STATE OF NORTH CAROLINA
DEPARTMENT OF TRANSPORTATION

September 10, 2007

SUBJECT: Permit Modification Request for TIP No. R-2809A, Wake Forest Bypass,
From west of Thompson Mill Road to east of Jones Dairy Road, Wake
County, Federal Aid No. HPSTP-55 (12), State Project No. 8.1402501:

Site 1-UT1 to Horse Branch (Original permitted as Site numbers 1 and 2), Sheets 4 and 5 of 19

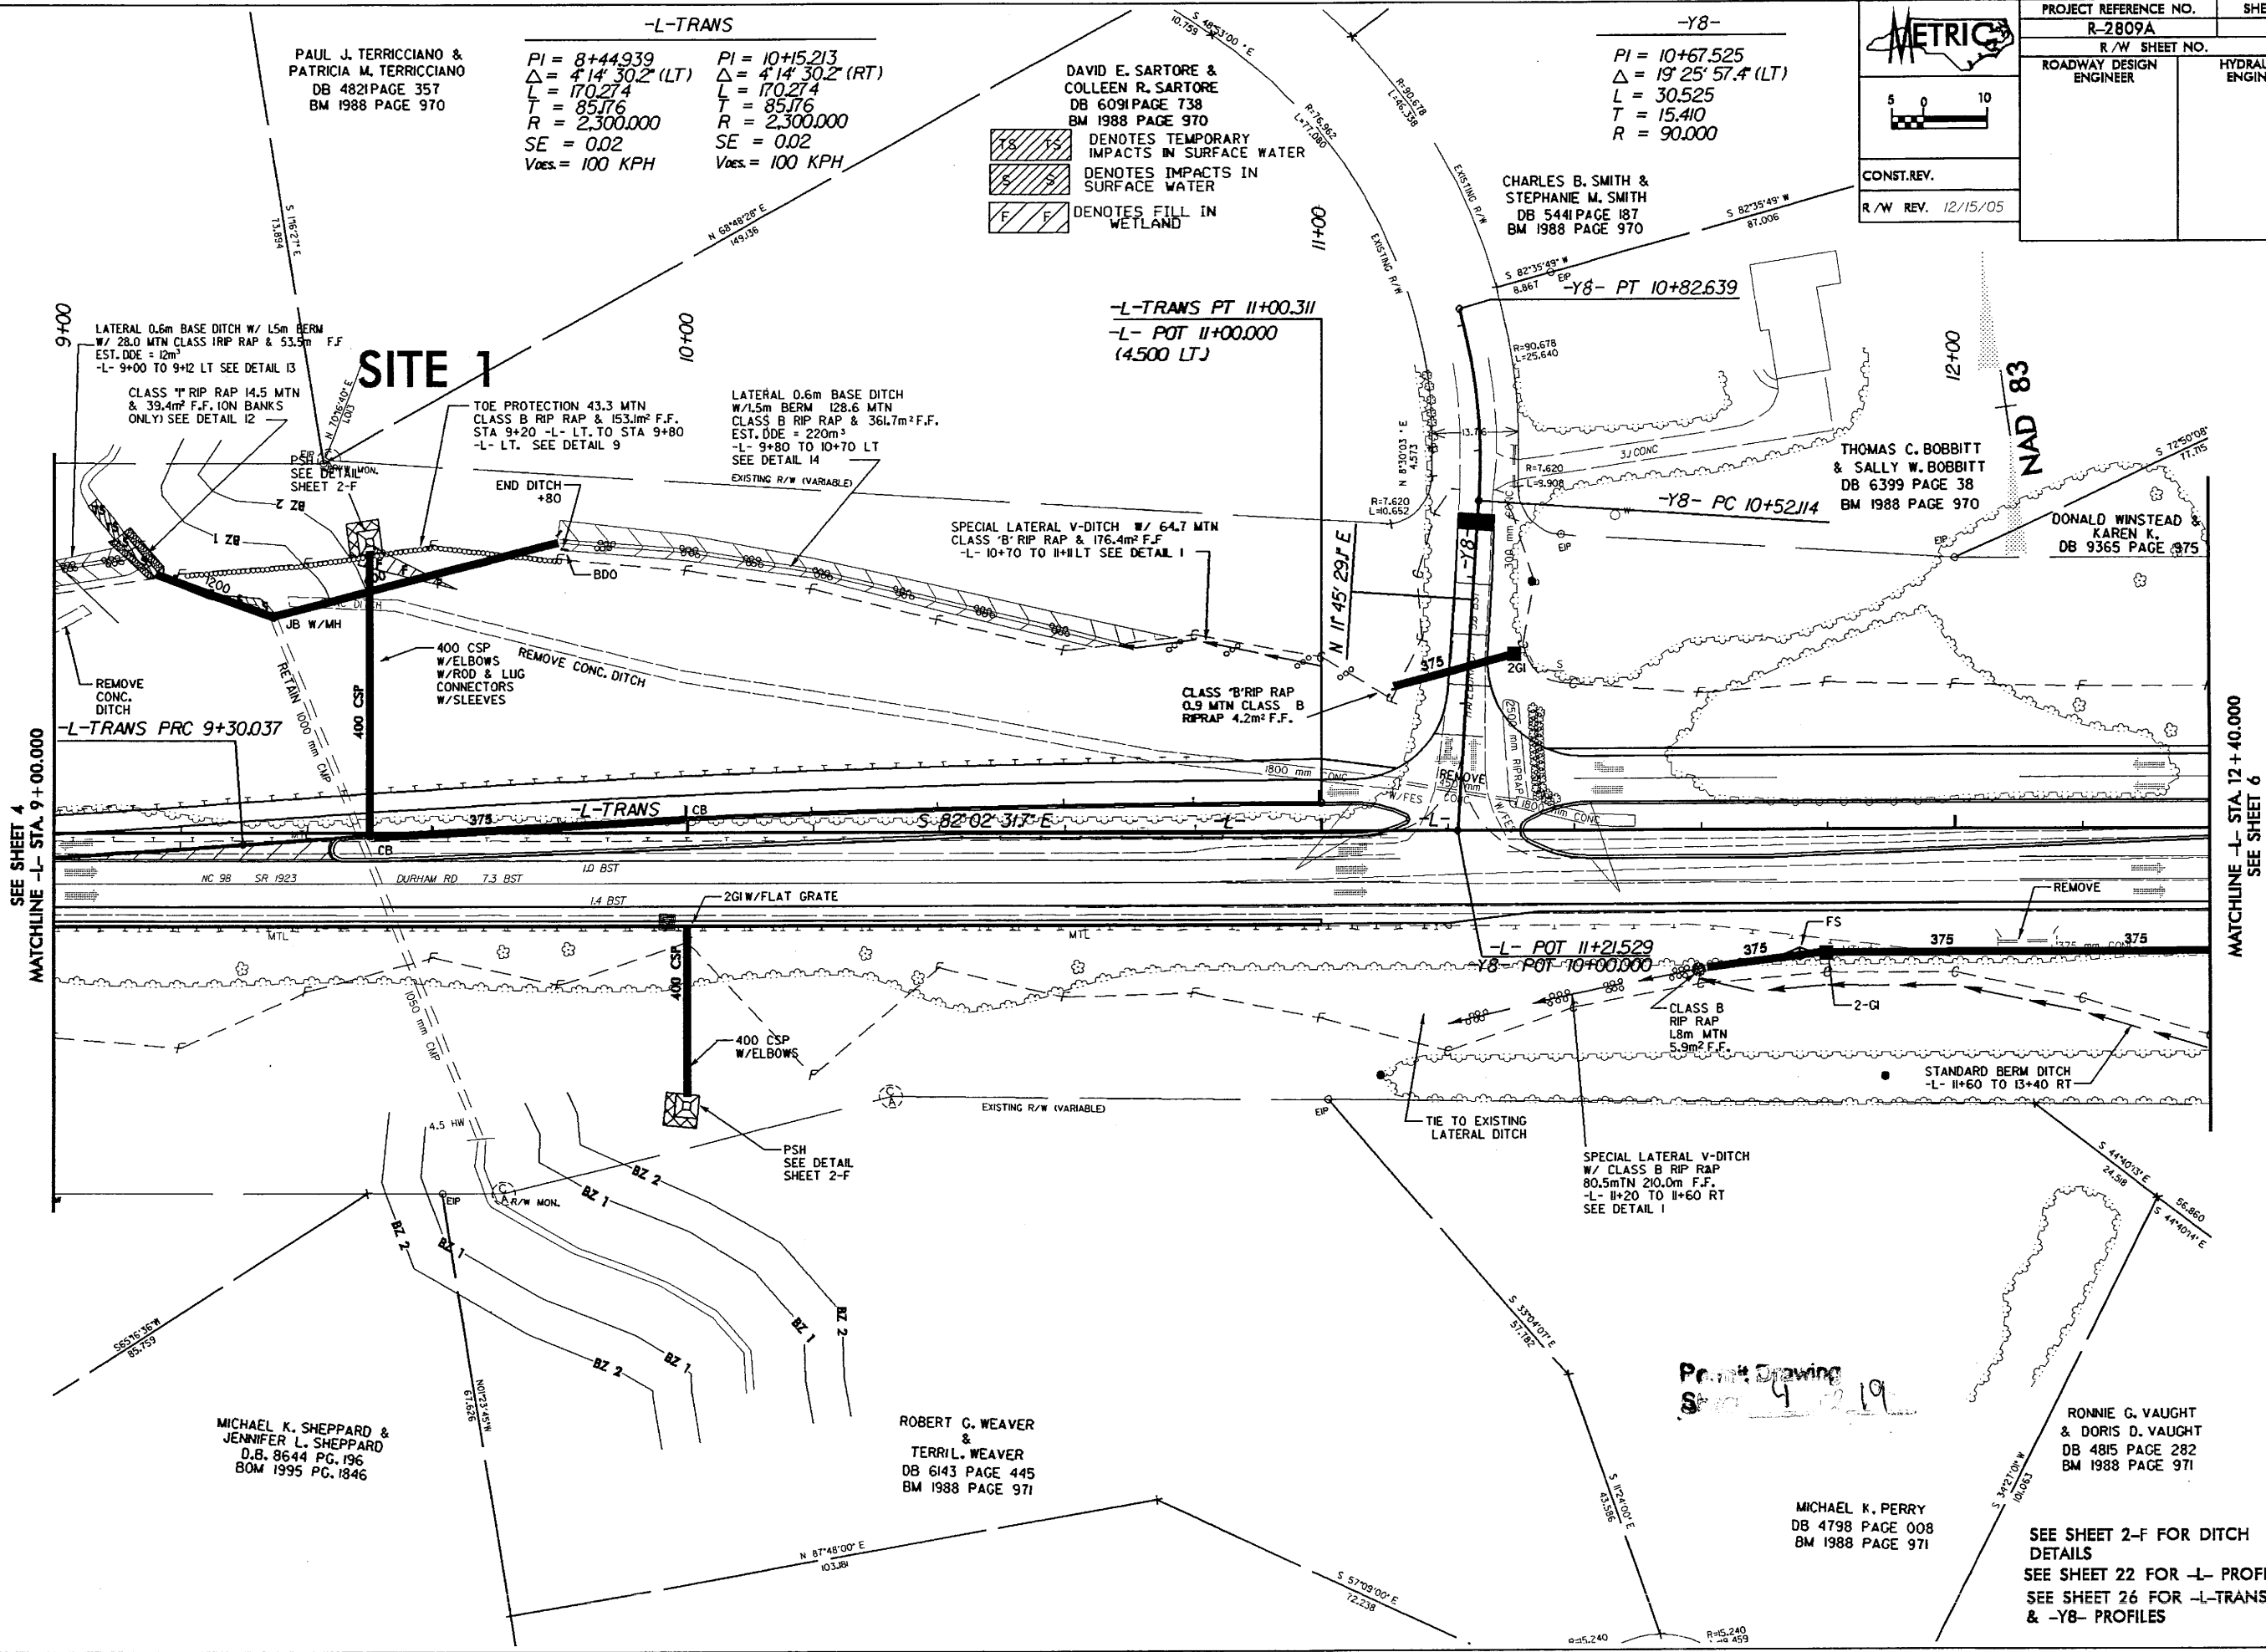
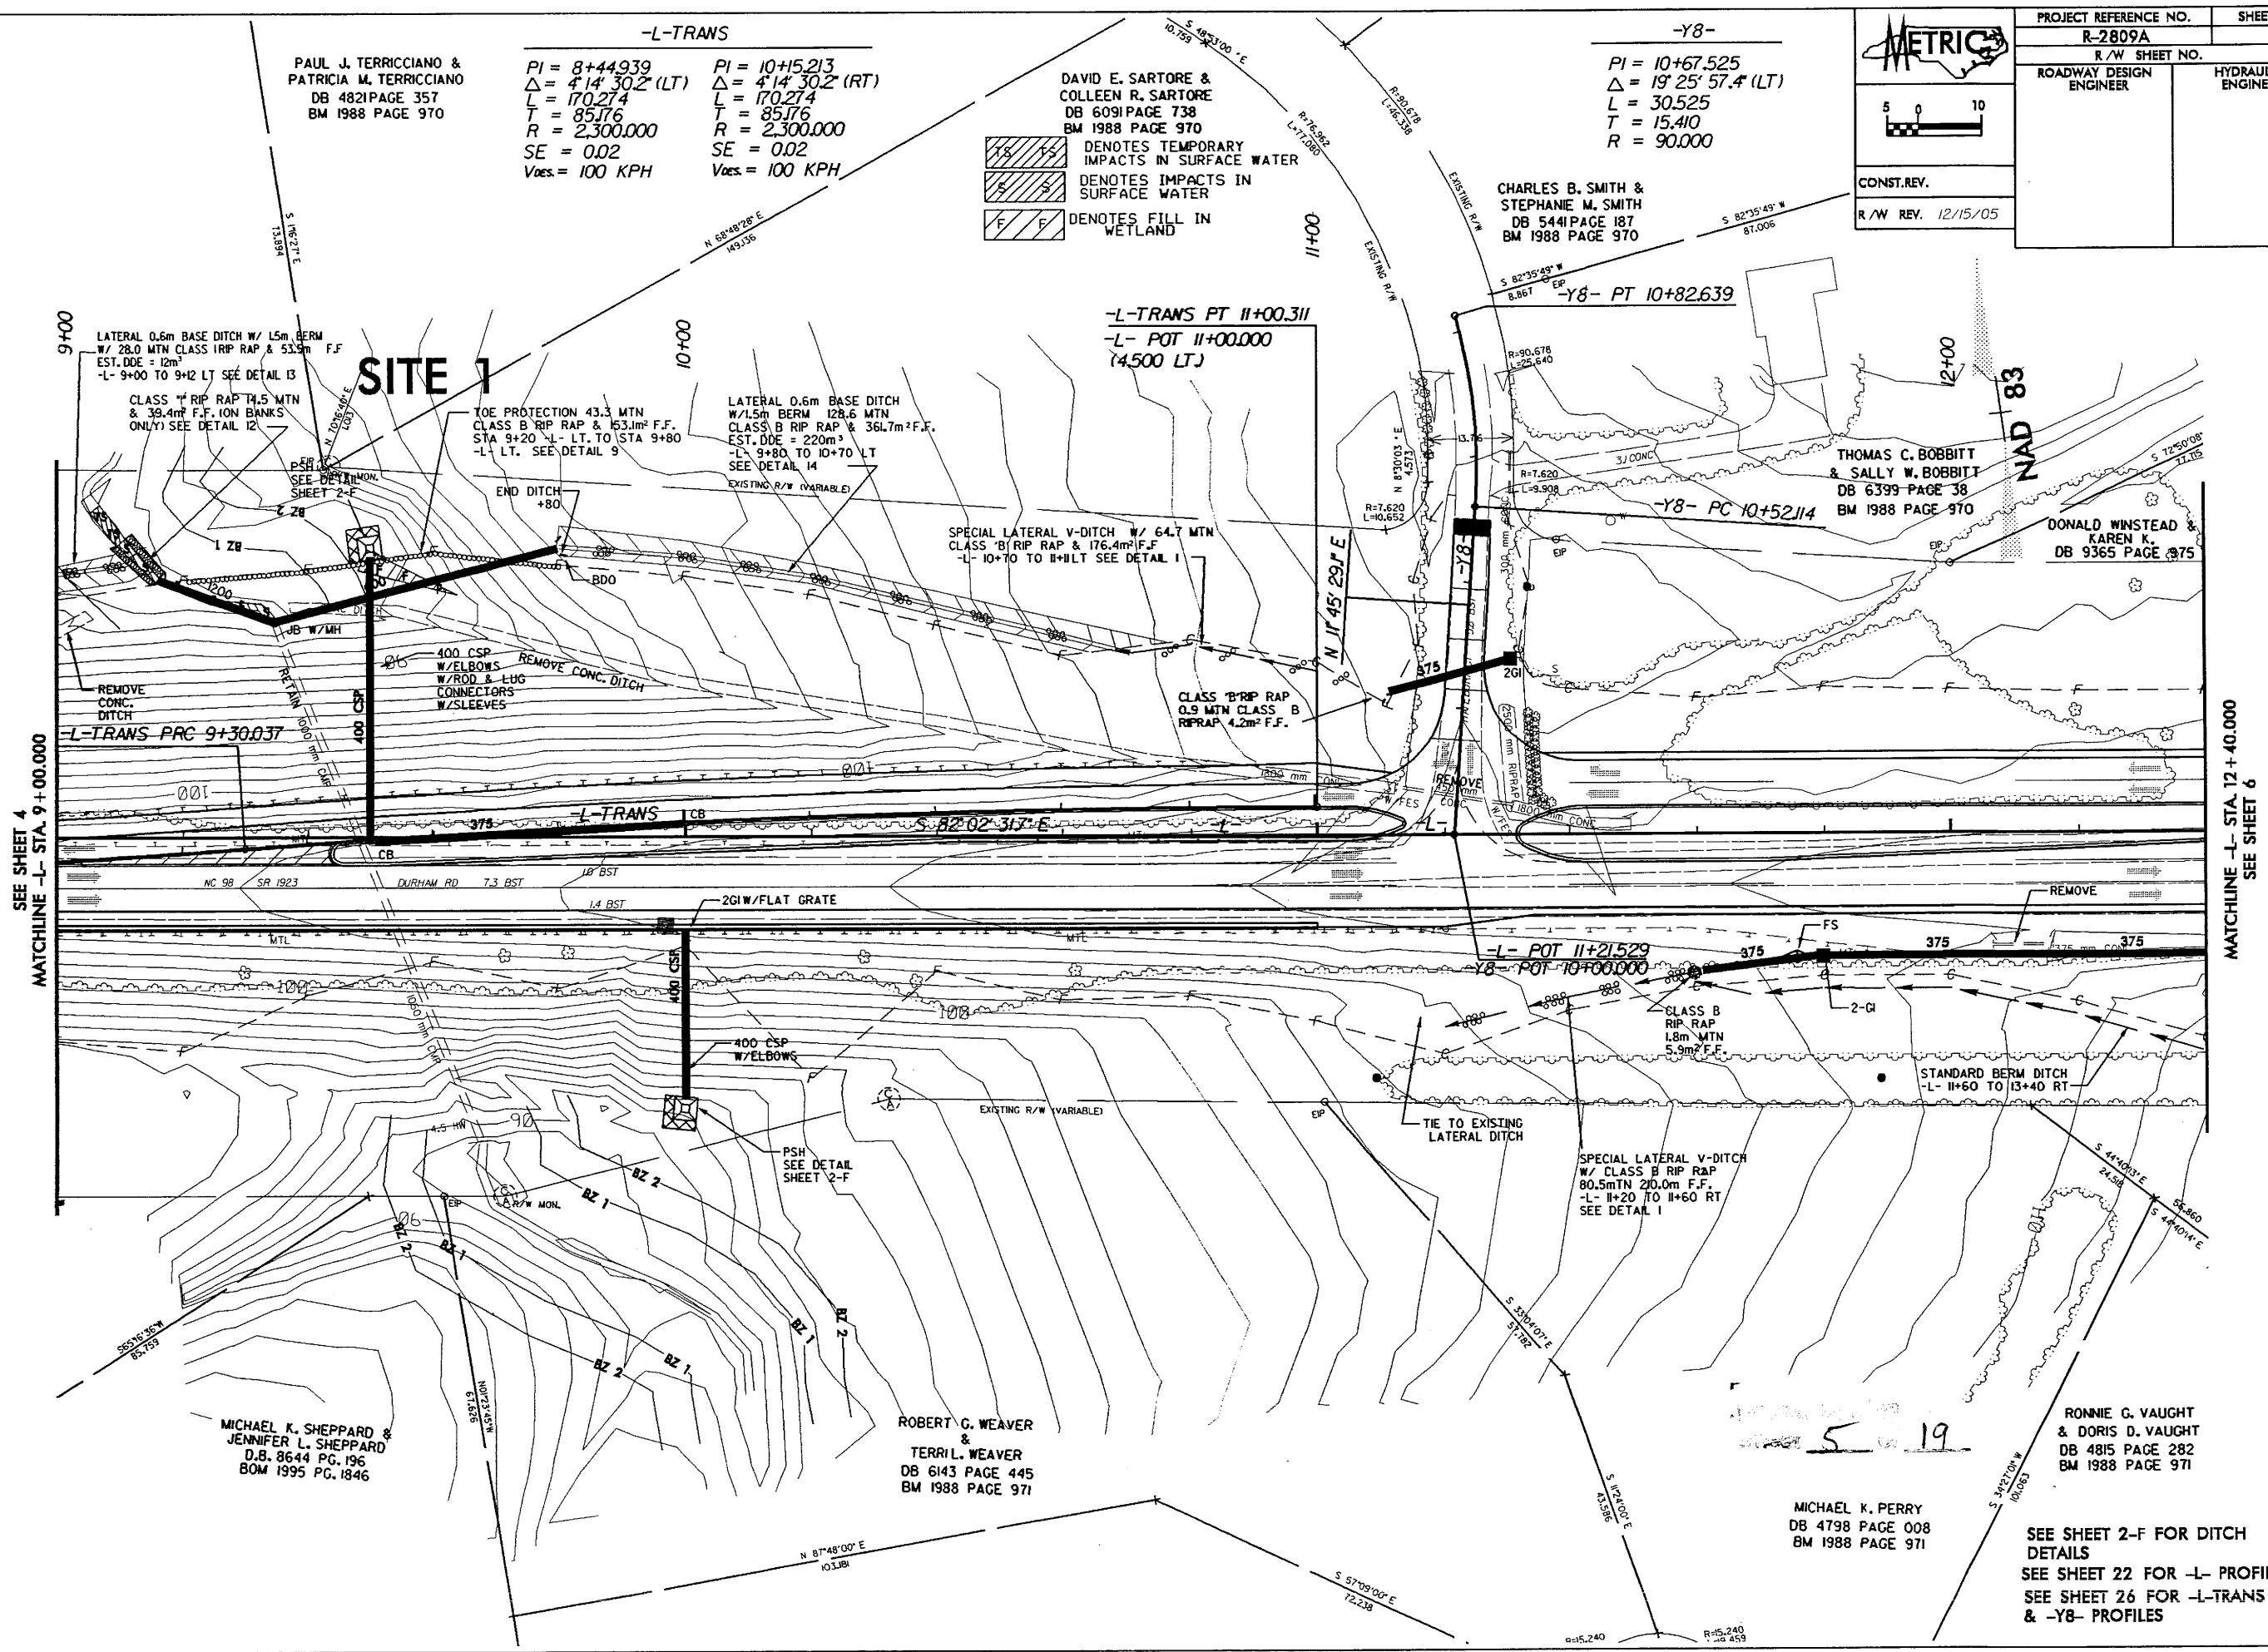
On the north side of existing NC 98, the existing 40-inch corrugated metal pipe (CMP) in UT1 to Horse Branch (UT1) will be extended with a junction box and a 48-inch corrugated steel pipe (CSP). A 24-inch CSP will also convey water from a lateral base ditch east of UT1 into the new 48-inch CSP. Construction of the lateral base ditch will allow for the removal of an existing concrete ditch. Two preformed scour holes will also be constructed at the outlet of the two 16-inch CSPs carrying storm water from the roadway and discharging prior to entering the buffer. Extension of the pipe and the associated work will result in 0.01 acre of fill in non-riverine wetlands, 95 feet of permanent stream impacts and 23 feet of temporary stream impacts in UT 1.

**Impact change: increase of 5 feet of permanent impacts to UT1 to Horse Branch
 increase of 23 of temporary impacts to UT1 to Horse Branch**

Permit Drawing
Sheet 12 of 19

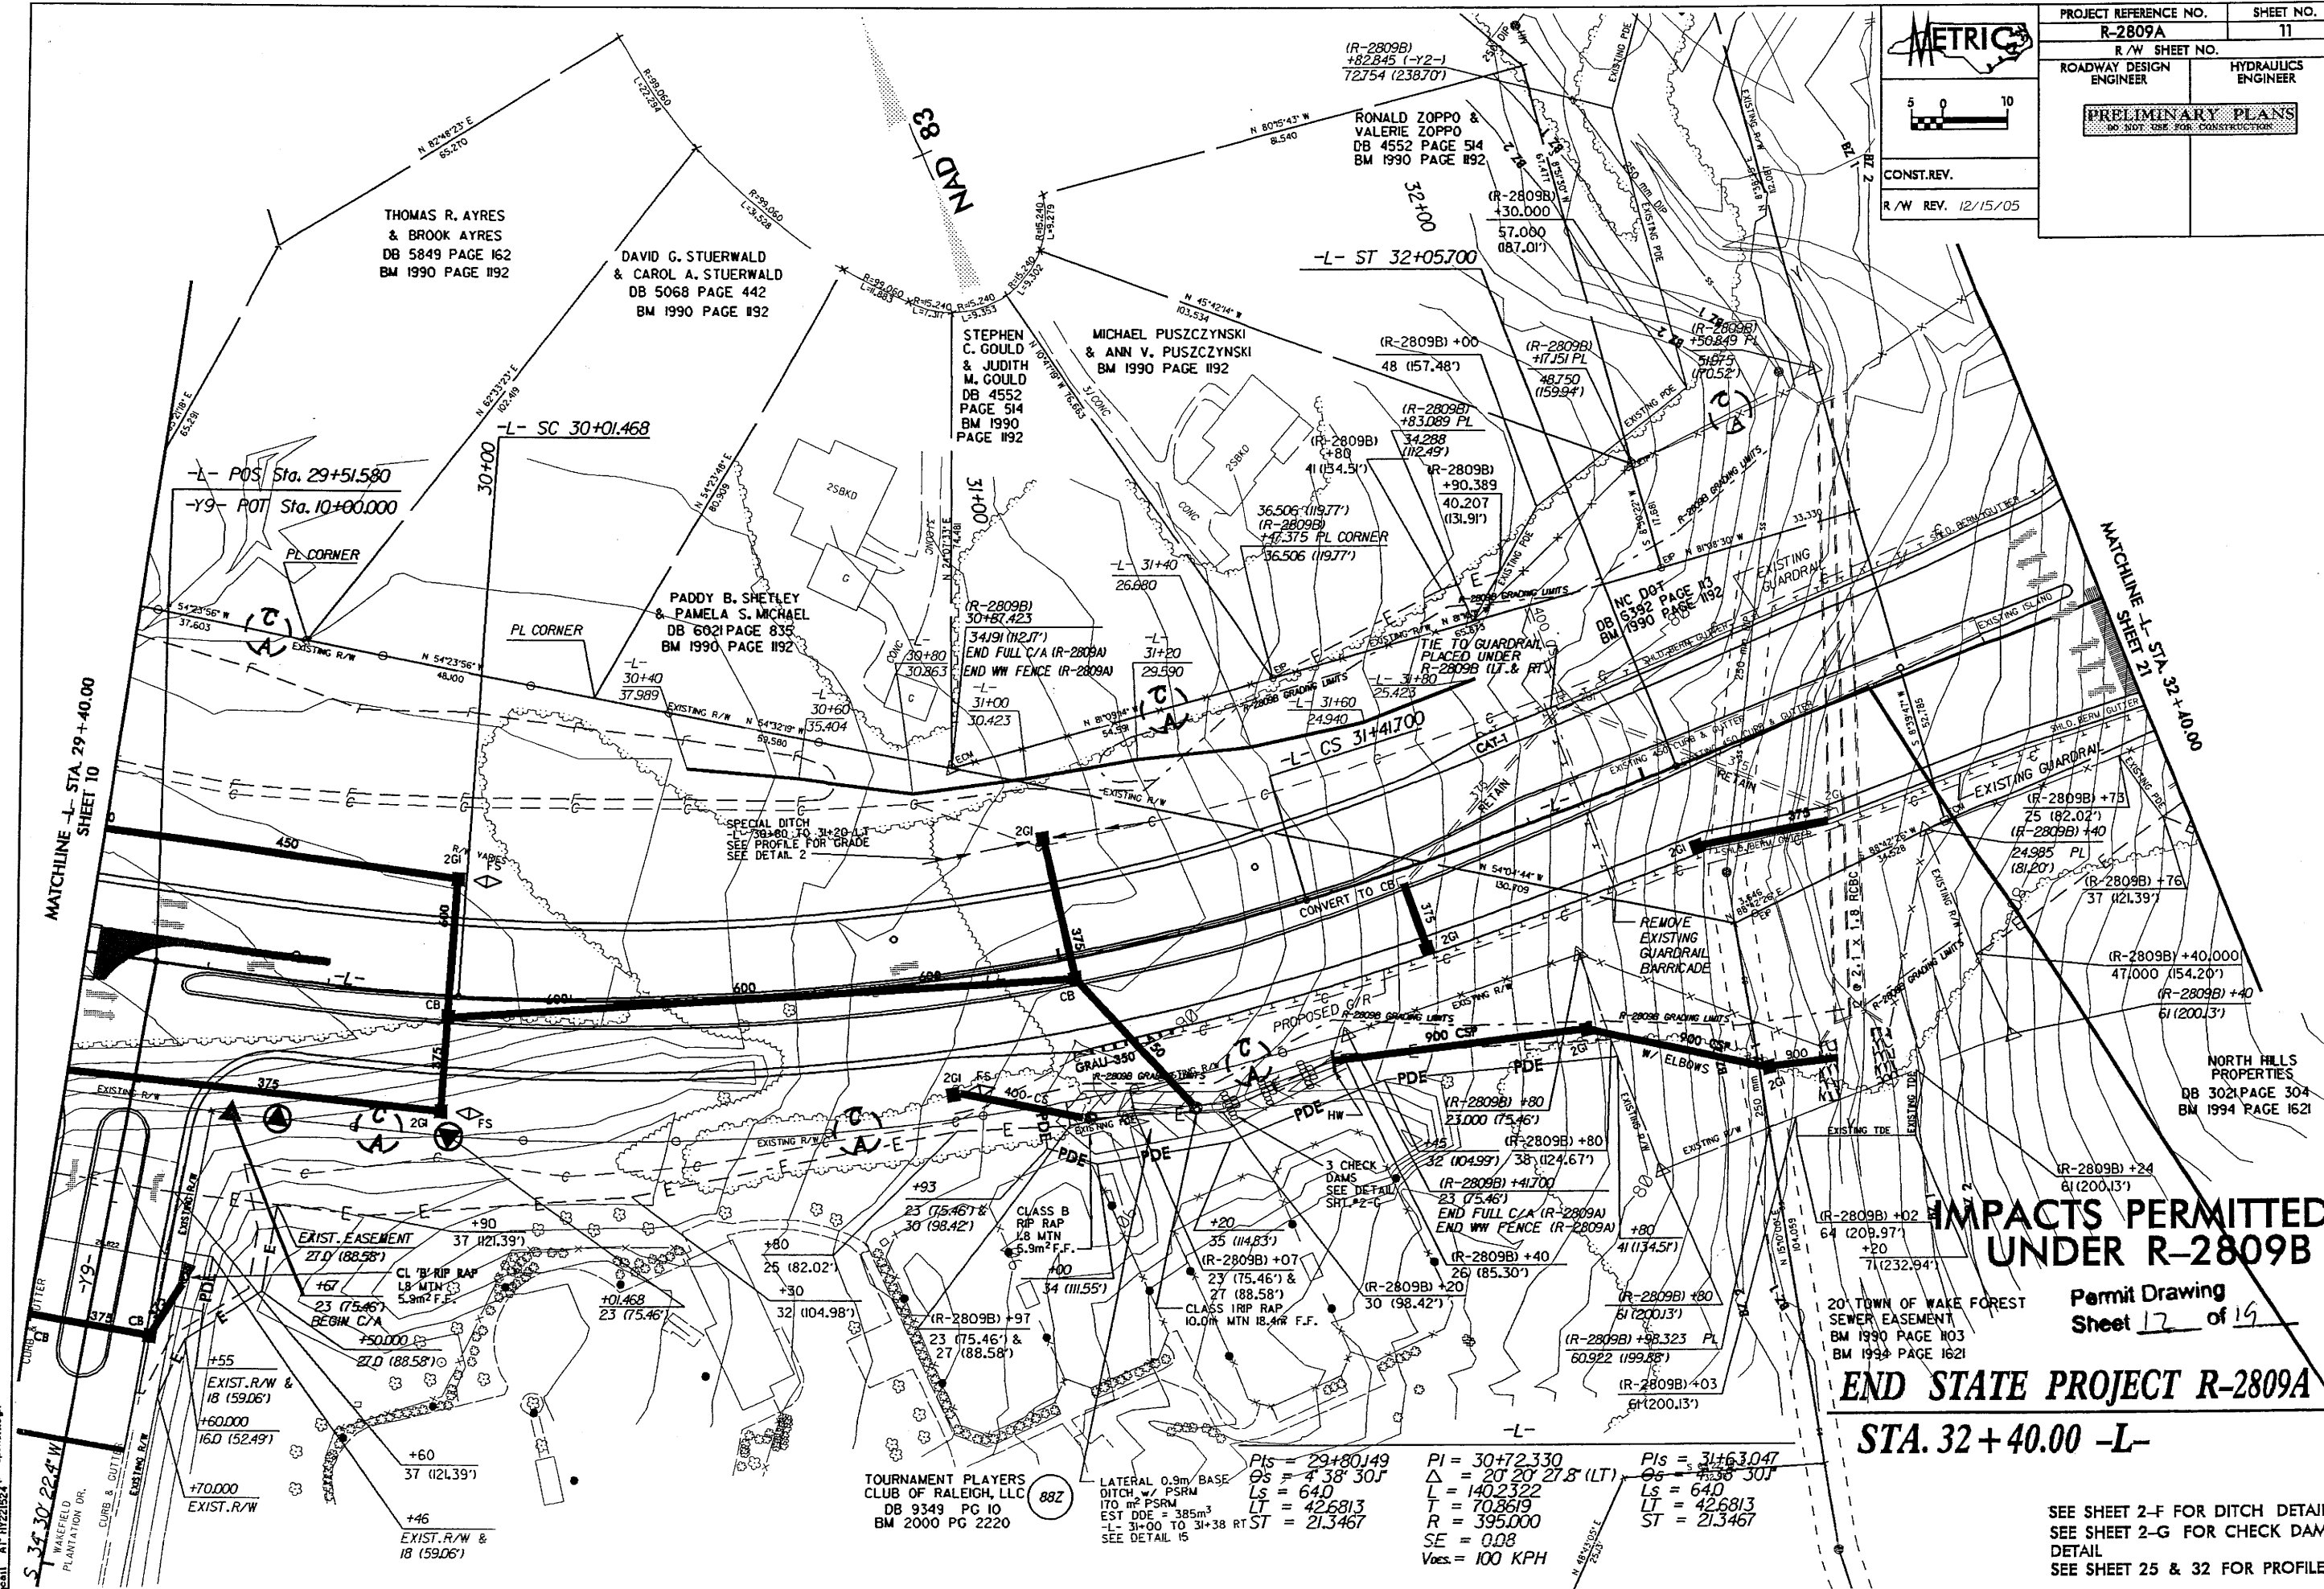
Need detail for rock checks in ditch 31+20 -L- Rt.

From 400 outlet Sta 32+00 Lt, show ditch prescribed on R-2809B project.
